[OCT 1919?]

House ~~B.~~ B. - or C
as seems best

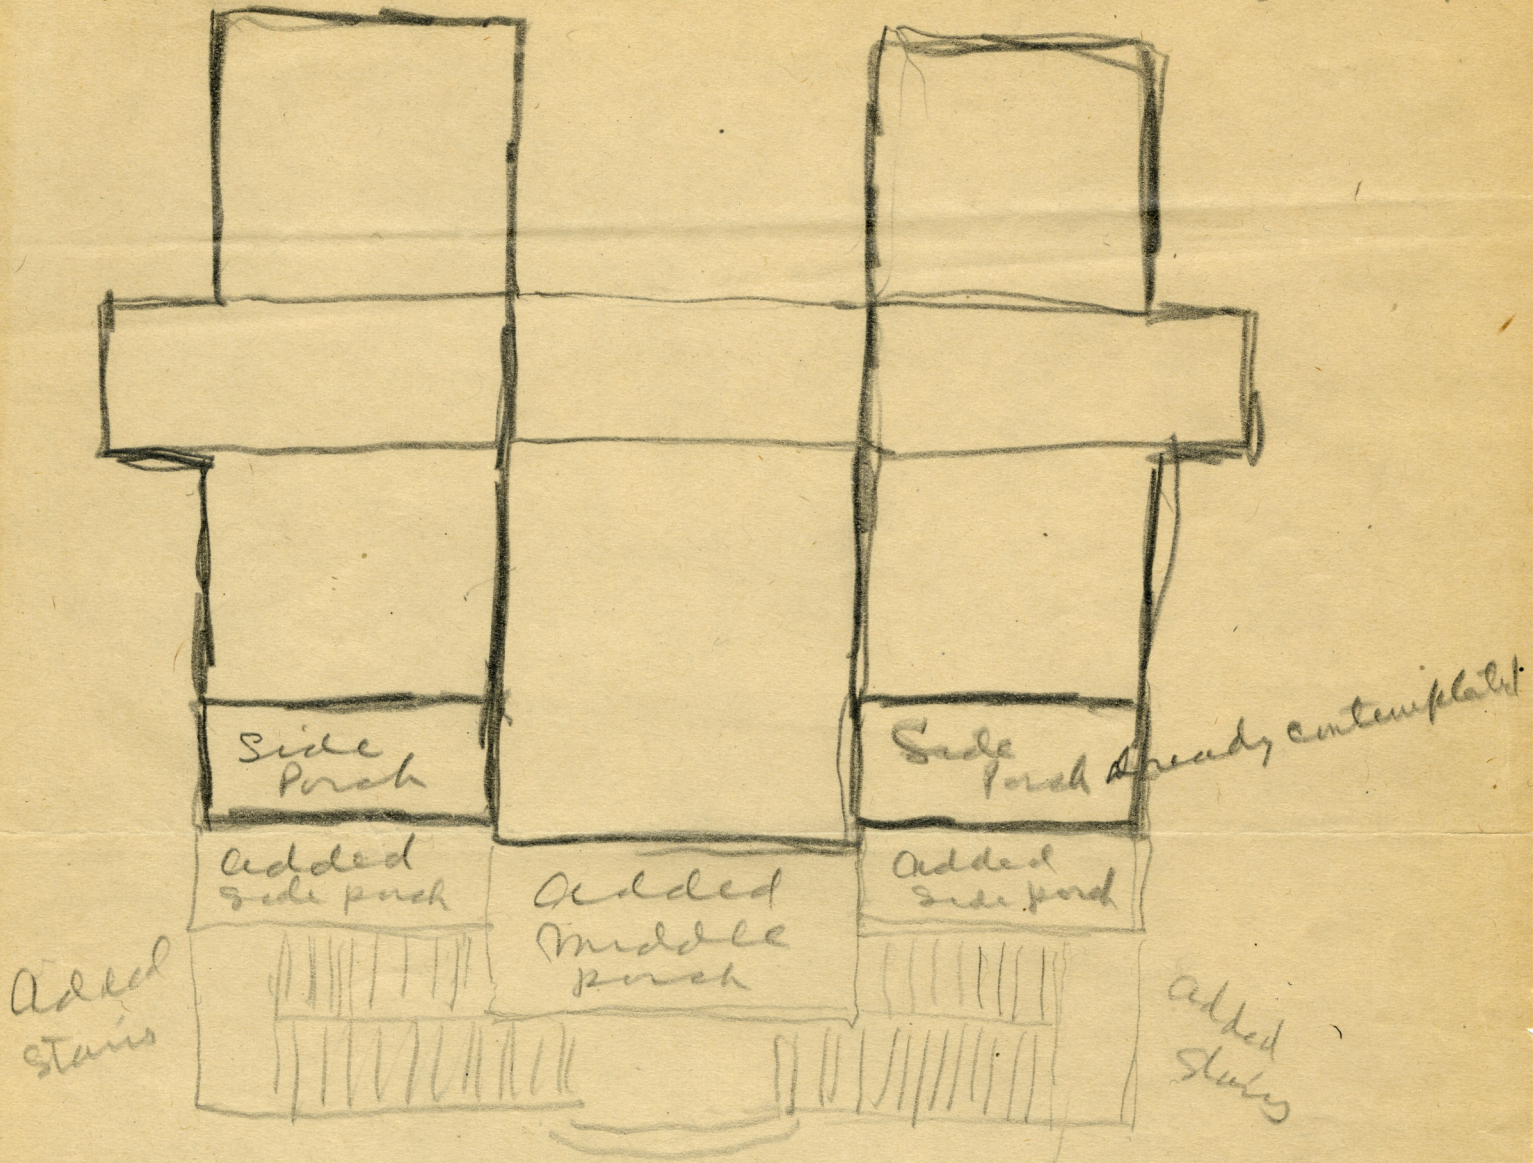
Black line shows house as originally drawn. Light lines show the additions I propose. There need be no change in bedrooms or parlor or any part of house proper. There are

merely additions of porches
and stairs on the view side.

The porch before the sitting room
or parlor is entirely new. The
porches in front of bed rooms are
there in part already but are
made deeper to reach to about
the middle of the central porch.

The stairs are added in entirety
but all of this is outside construction
and only on one end of the
building. There need be
no loggias on this scheme
and so the roof plans need
not be affected, but if you
want loggias on this plan I think
they would be better over the side
porches for a change, leaving the
middle porch open. WRS

Outside addition to house C. — or B
if this should suit B better then use other one for
C.

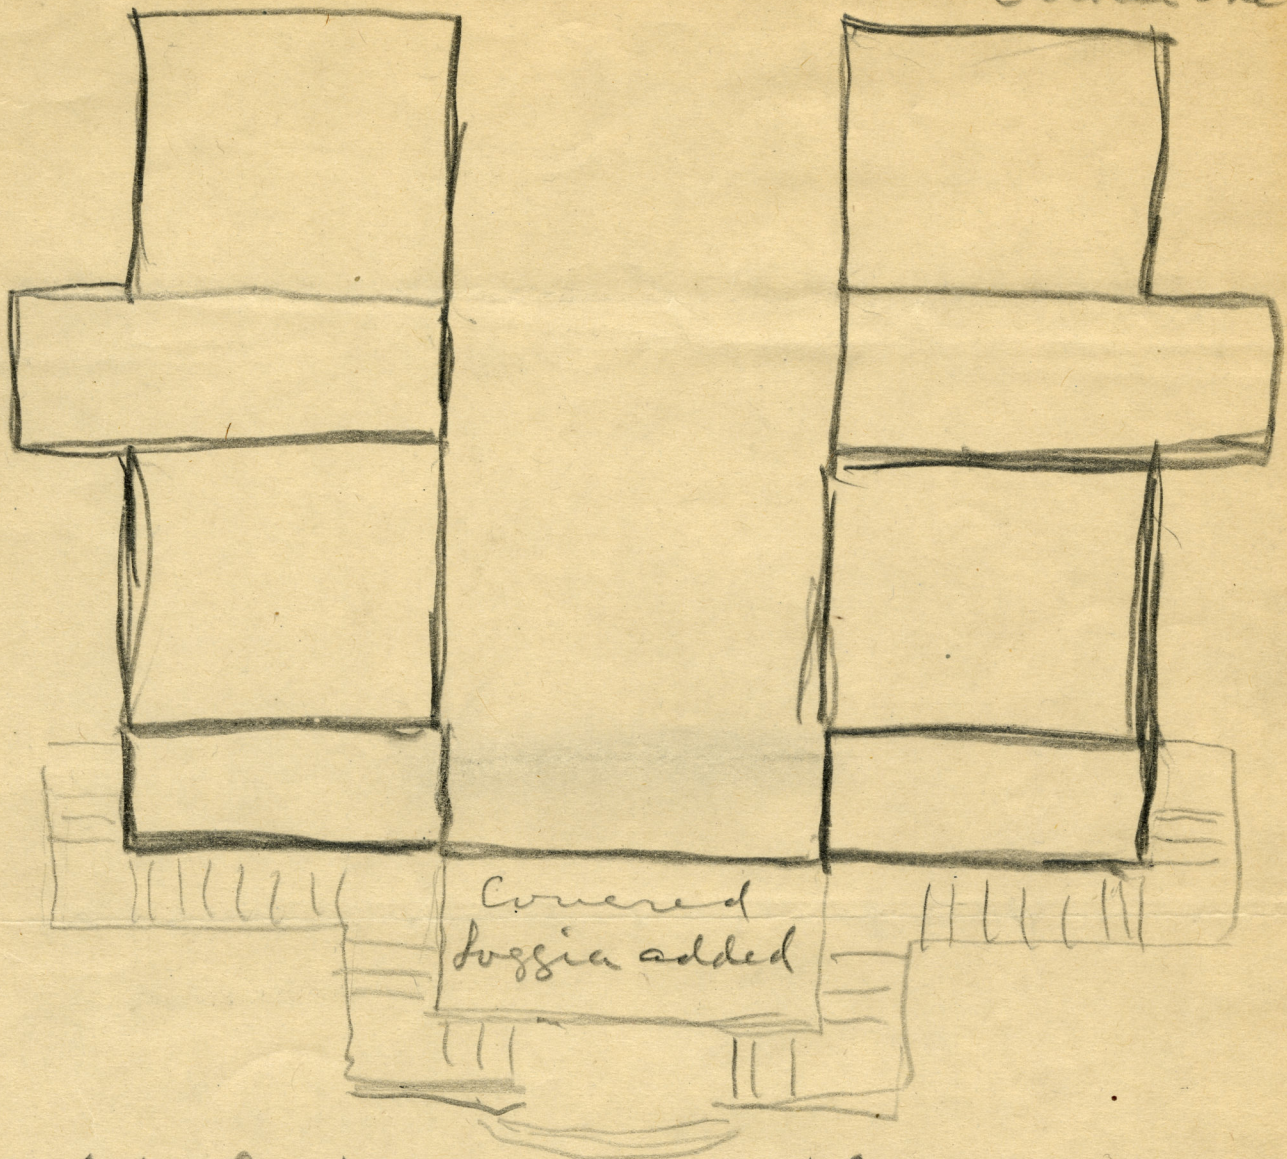
Light lines show the covered
loggia and the stairs added
to the view side of the house
It is all outside construction
except that the covered loggia
will require an altered roof
plan tracing for which I have
already sent in previous note.

I suggested in previous note that if we had not started to build yet we could lengthen the house thus making little deeper court, longer bed rooms and more spacious parlor but this need not be considered as difficult to accomplish or if we have already begun to erect walls.

The additions advised in this present letter are all outside additions and can be added to the houses if even if they were finished.

I think covered center loggia would be ~~the~~ better for house C and the other plan for B but if the ground conditions required they could be interchanged Sincerely W R Hunt
